NEW YORK HARBOR
CHANNEL NAVIGATION IMPROVEMENT 50 FT PROJECT
AMBROSE CHANNEL

CONTRACT2
S–AM–1
W912DS–05–B–0012

COVER SHEET,GENERAL PLAN AND INDEX TO DRAWINGS

CROSS SECTIONS STA.-24+00 TO STA.156+00

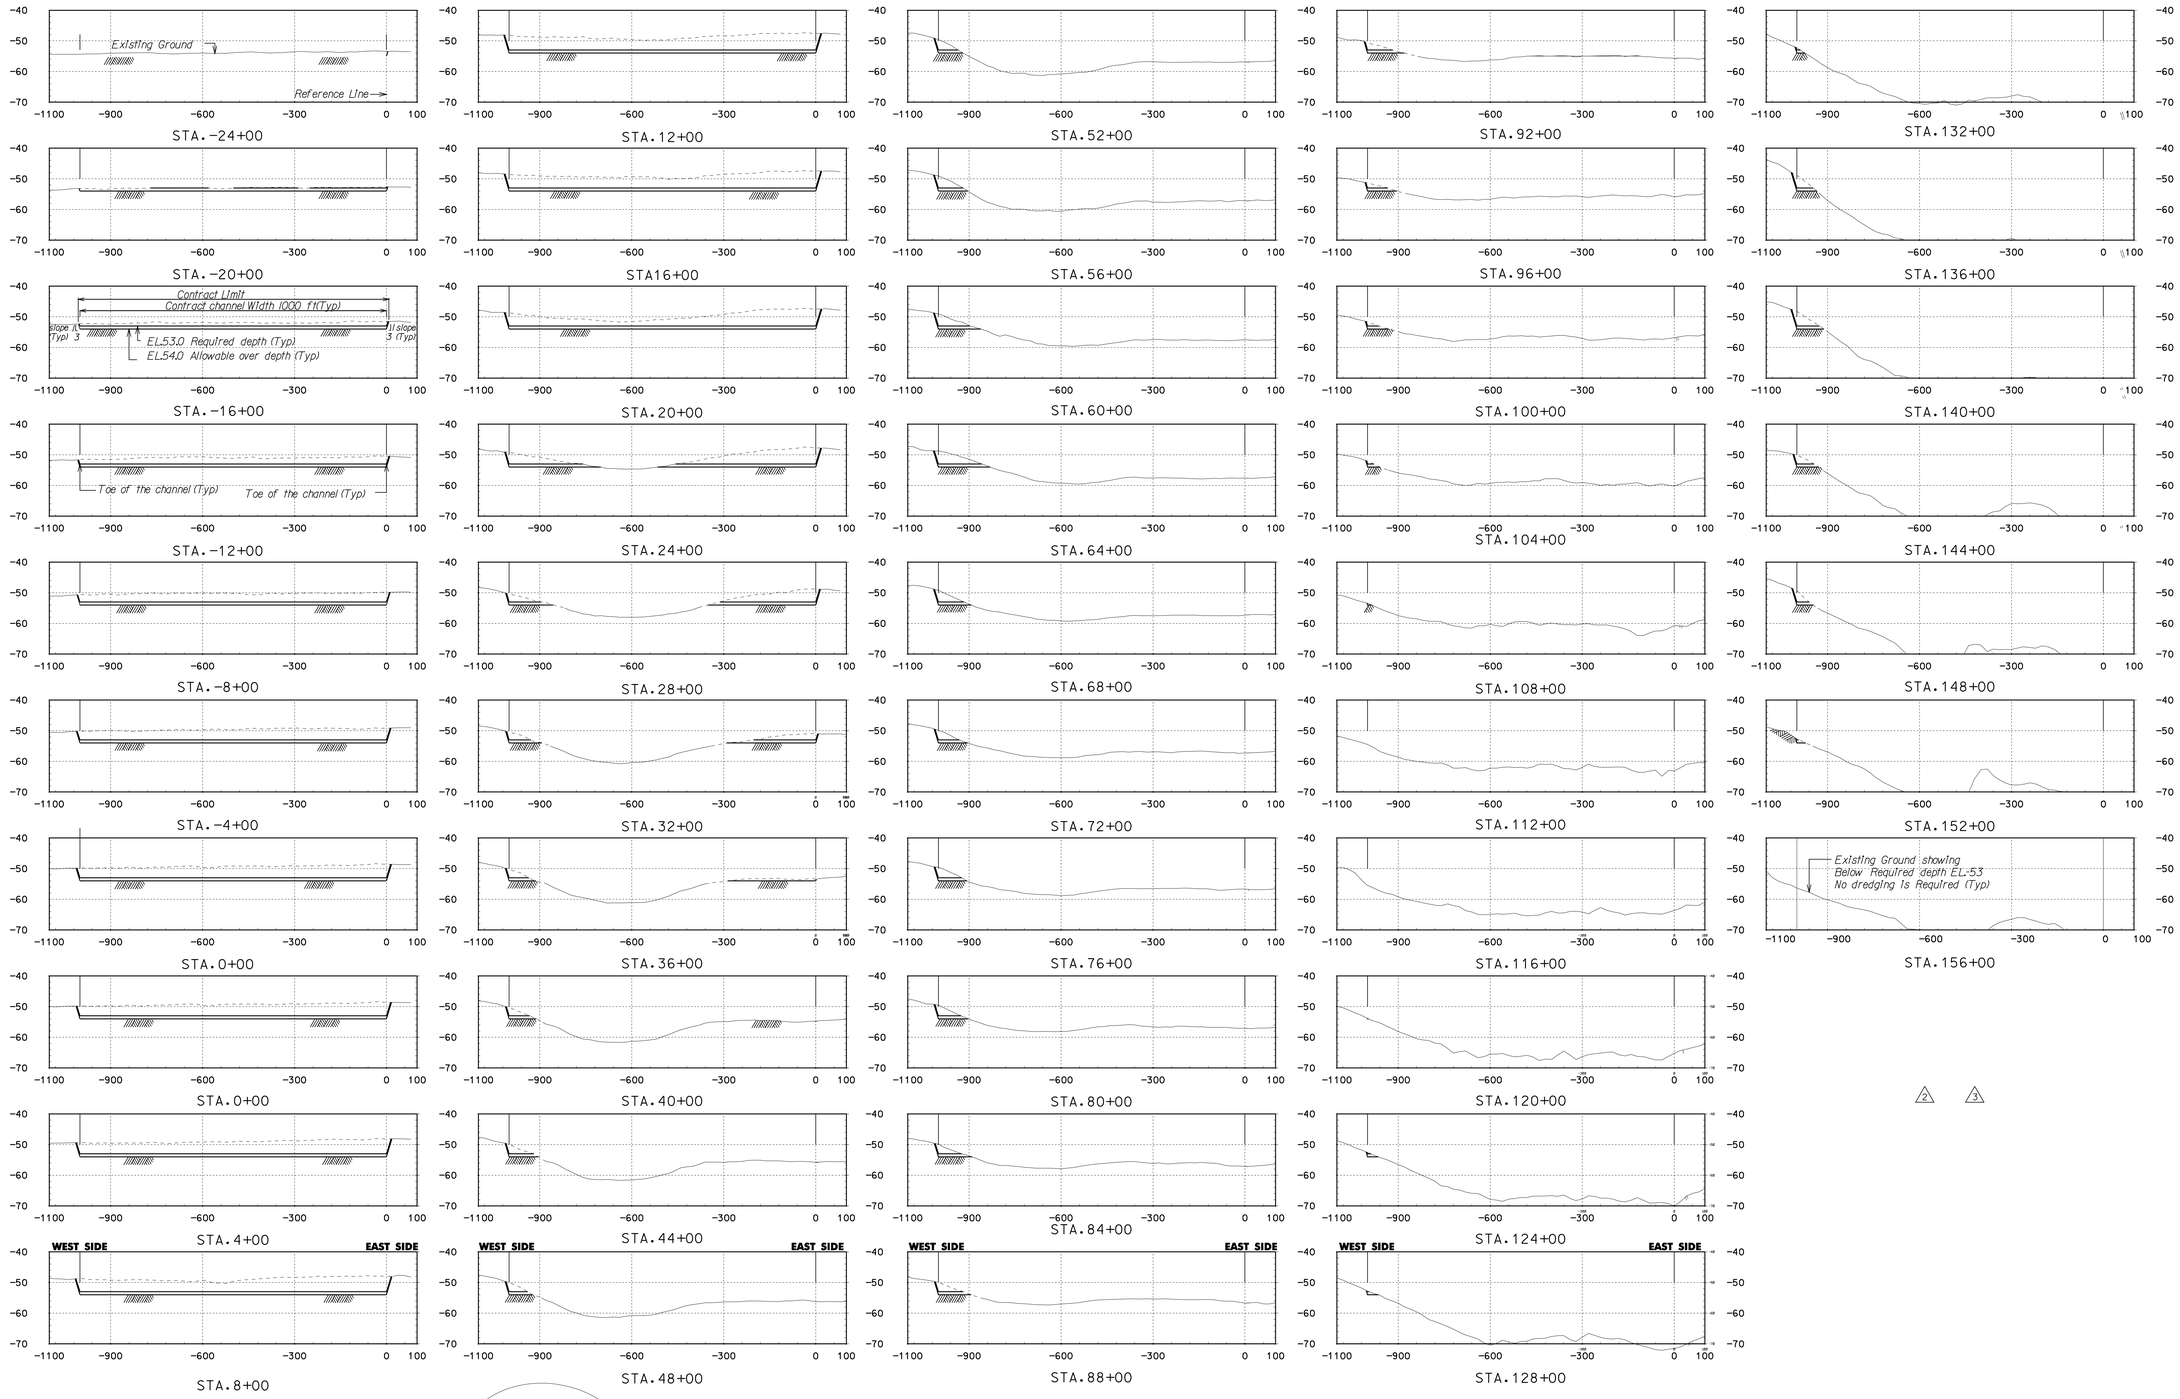
Symbol	Description	Date	Appr.
3	Legend Is revised to Existing Undisturbed Earth Below allowable depth.Previous amendment 2 of plans completed on 7/19/05 should read amendment 6	8/12/05	G.A.
2	Legend Is revised to Existing Undisturbed Earth Below allowable depth.Previous amendment 1 of Plans completed on 8/8/05 should read amendment 4.	7/19/05	G.A.
1	Allowable Over depth Is Revised to 1.5 ft and allowable EL-54.5 ft over depth Is revised to EL-55.0	6/15/05	G.A.

CROSS SECTIONS STA.336+00 TO STA.484+00

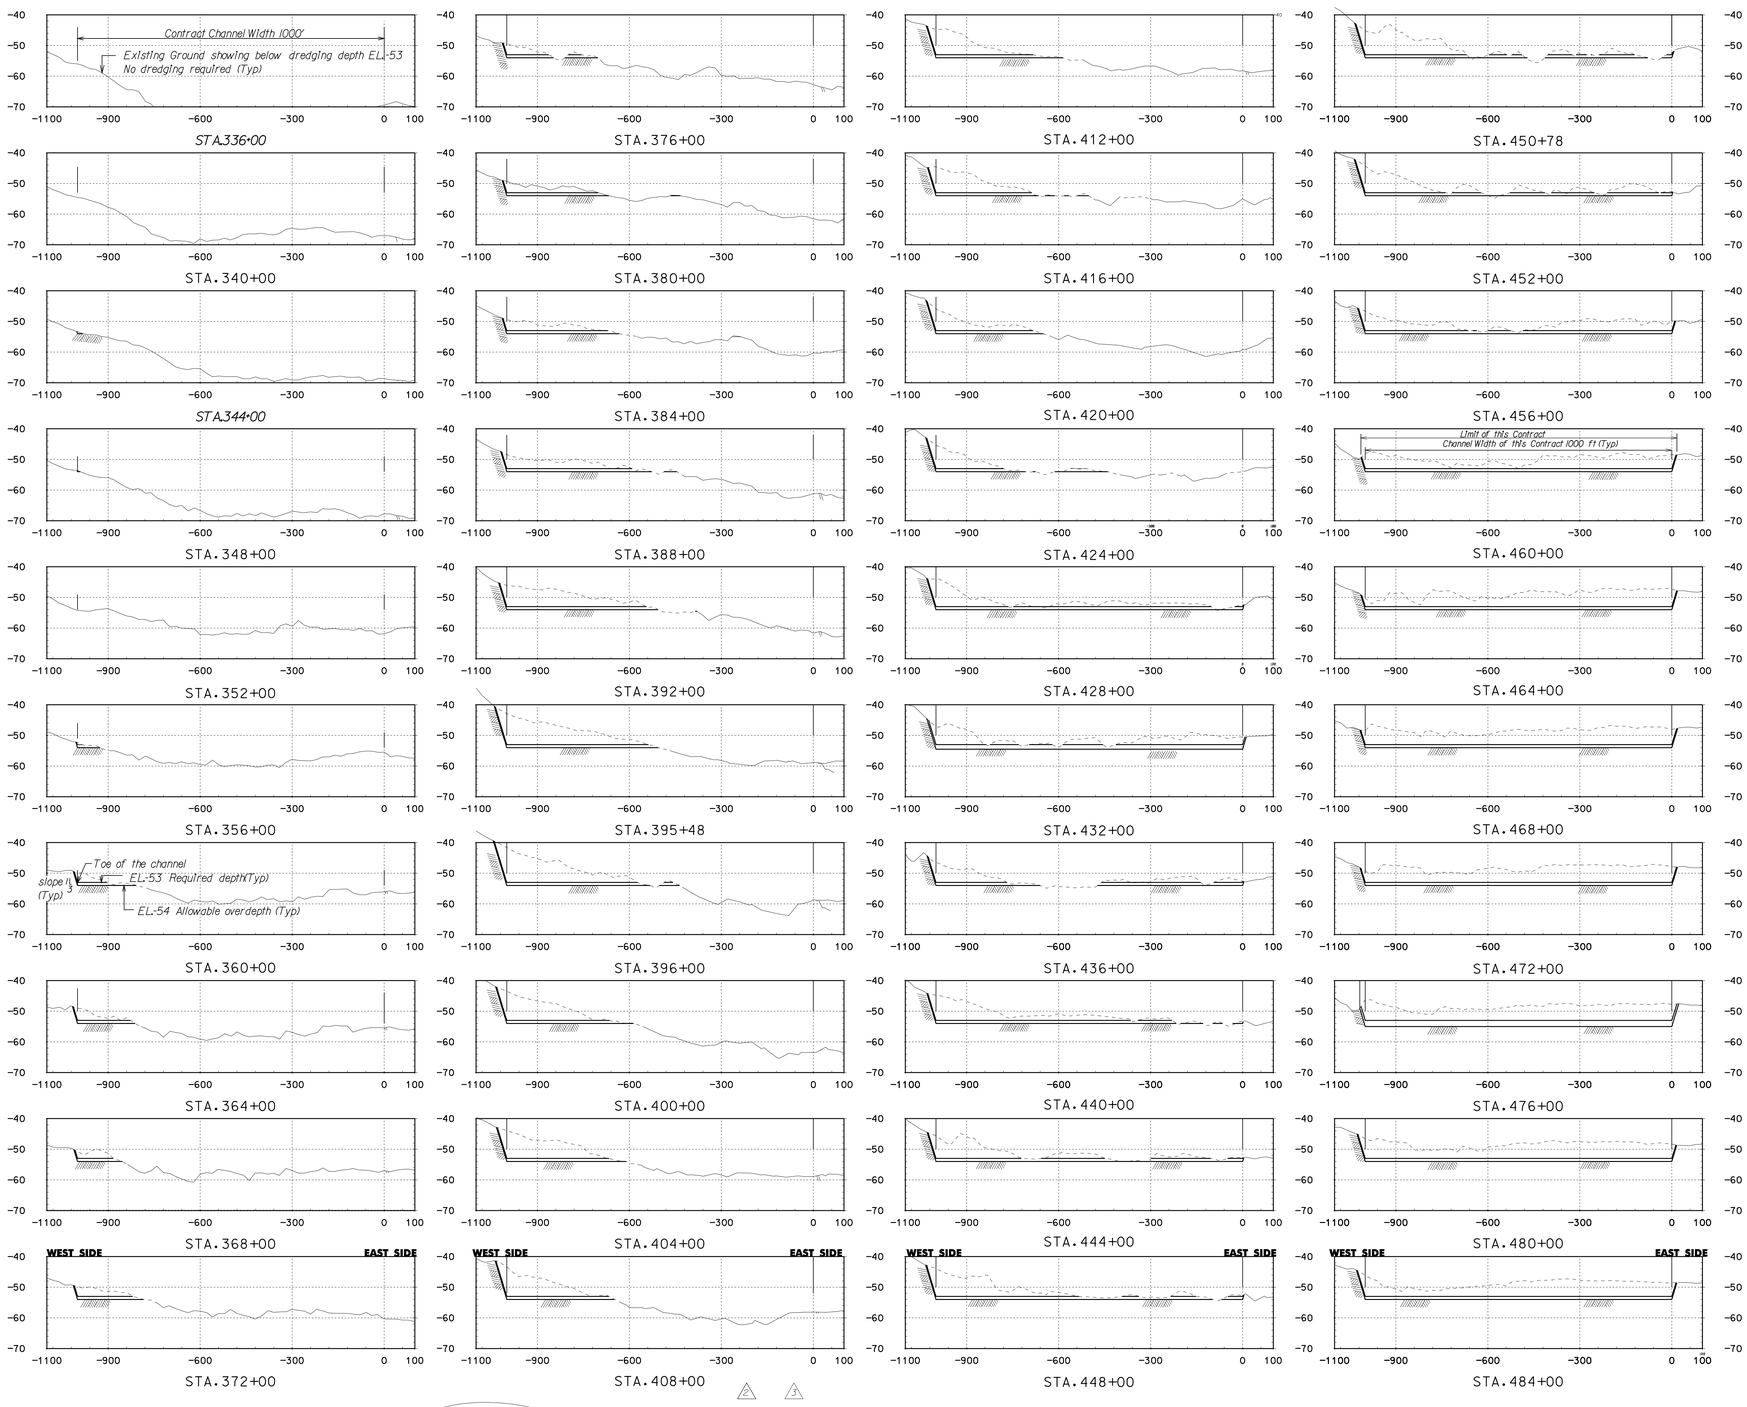
Symbol	Description	Date	Appr.
2	Legend is revised to Existing Undisturbed Earth Below allowable depth.Previous Amendment 2 of Plans completed on 7/15/05 should read amendment 6	8/12/05	G.A.
3	Legend is revised to Existing Undisturbed Earth Below allowable depth.Previous Amendment 3 of Plans completed on 8/2/05 should read amendment 5.	7/15/05	G.A.
4	Allowable overdepth is revised to EL-44 and maximum 5:1 slope depth is Eliminated. Allowable overdepth is revised to EL-44.5 and Uppdd maximum 5:1 allowable overdepth is revised to EL-55.0	7/15/05	G.A.

CROSS SECTIONS STA.488+00 TO STA.680+00

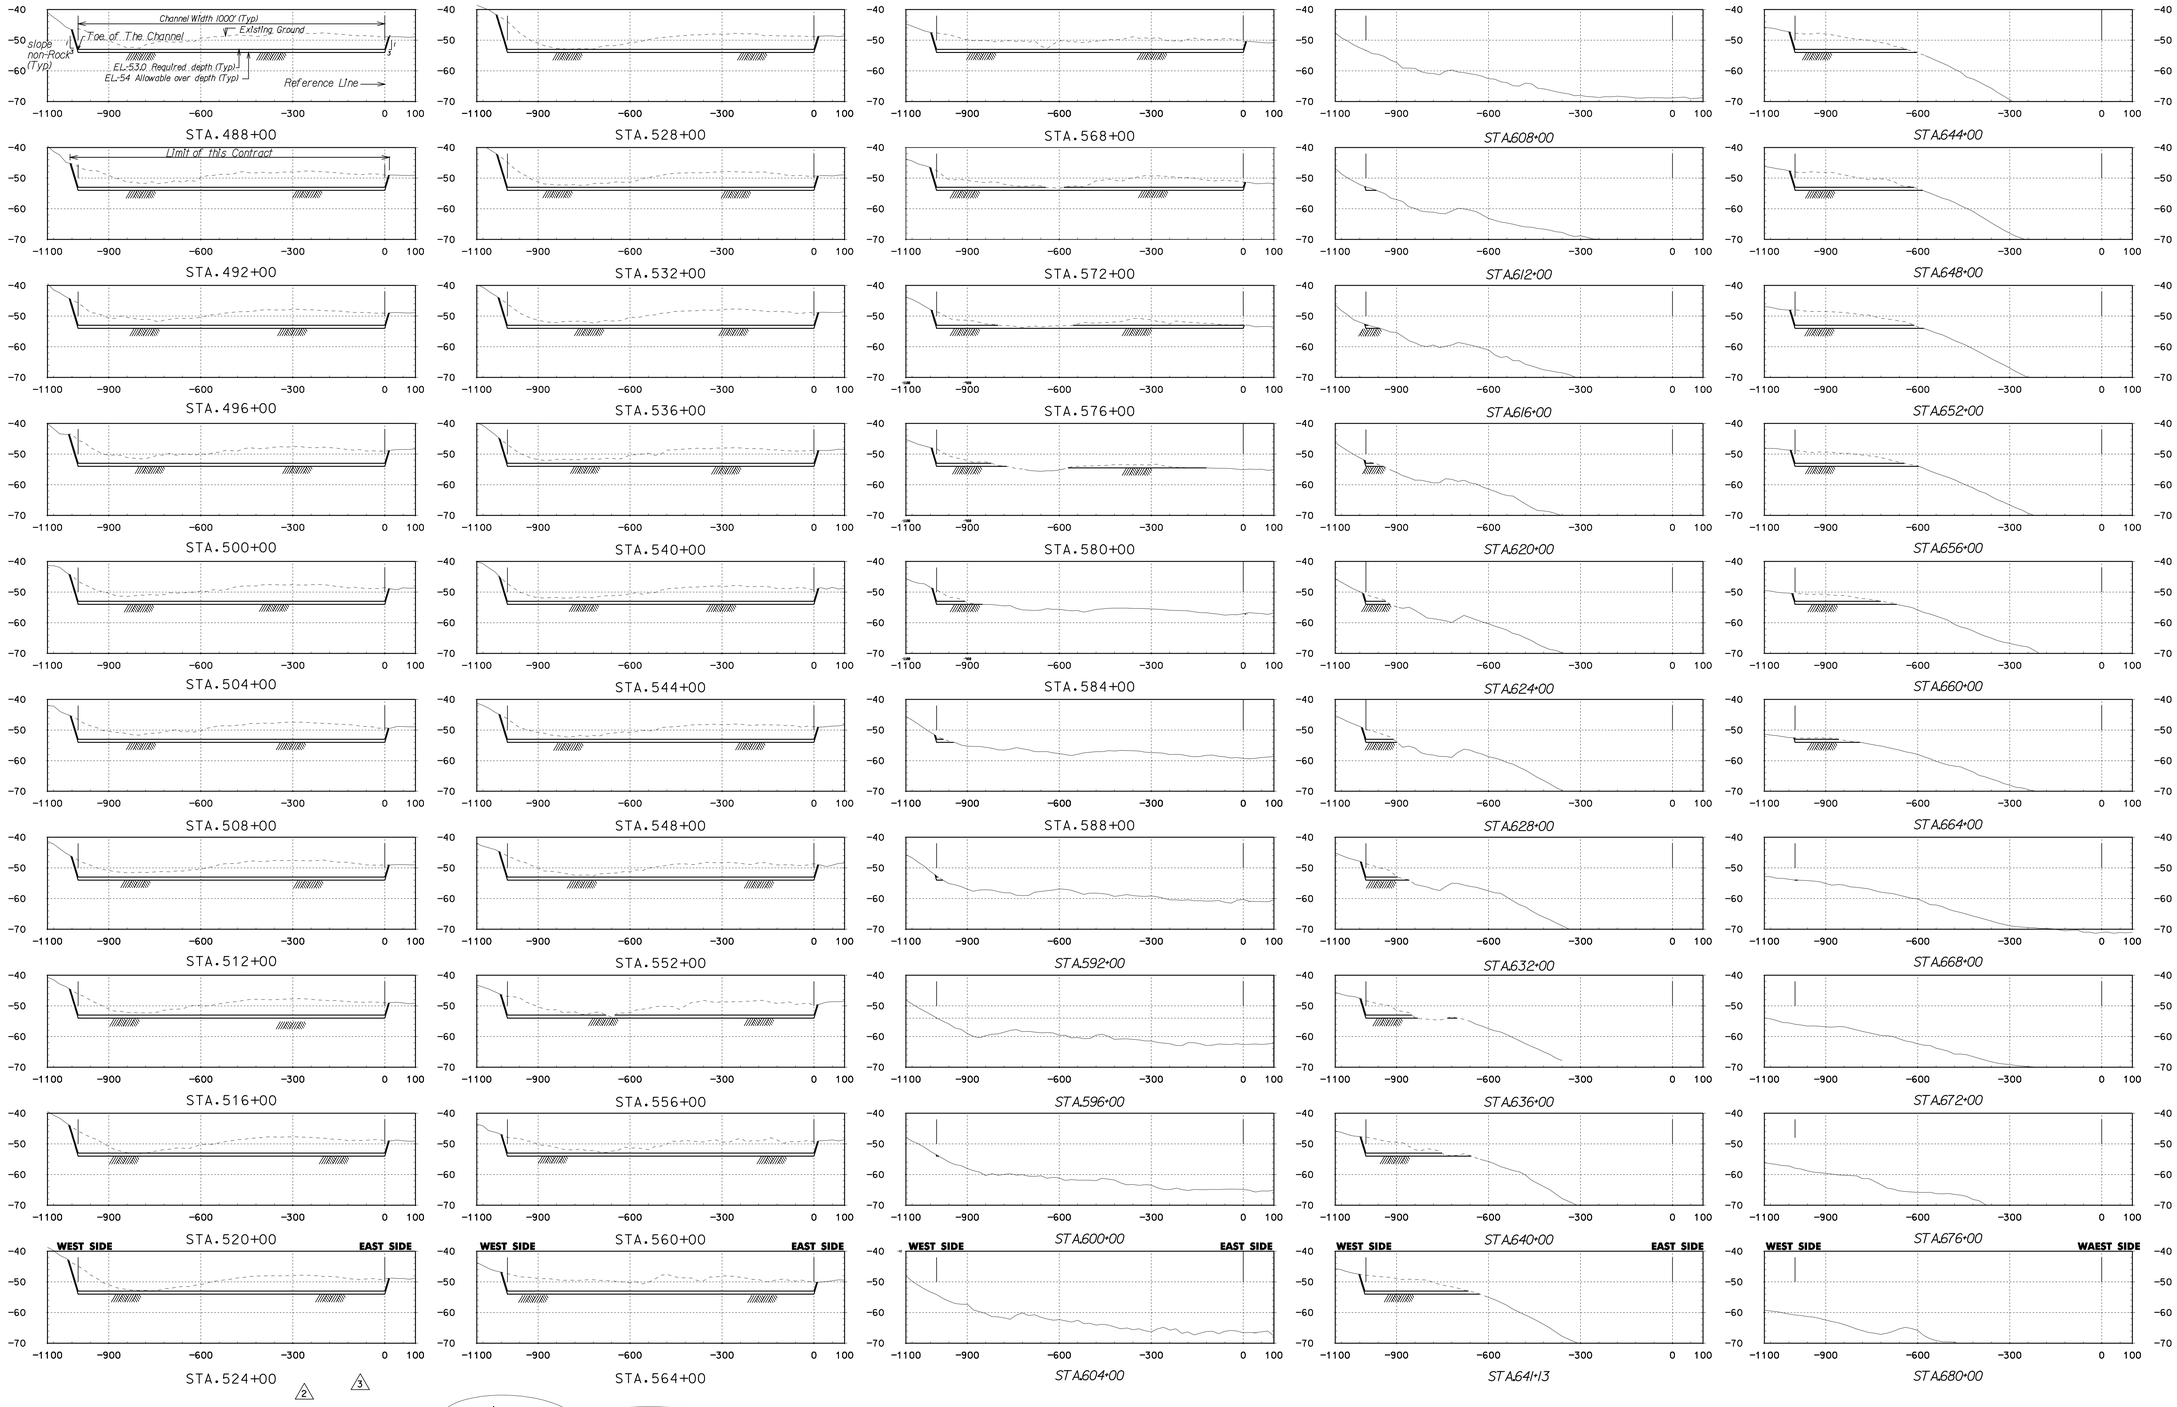
Rev.	Description	Date	Appr.
2	Legend is revised to Existing Undisturbed Earth Below allowable depth. Previous amendment 2 of plans revised on 7/19/05 should read amendment 6 and amendment 3 of plans revised on 8/16/05 should read amendment 8.	8/16/05	G.A.
1	Allowable over depth is revised to EL-54 and Minimum required depth is defined as Allowable over depth is revised to EL-530 and Minimum is 5.5 (typical) Allowable over depth is revised to EL-550.	7/19/05	G.A.
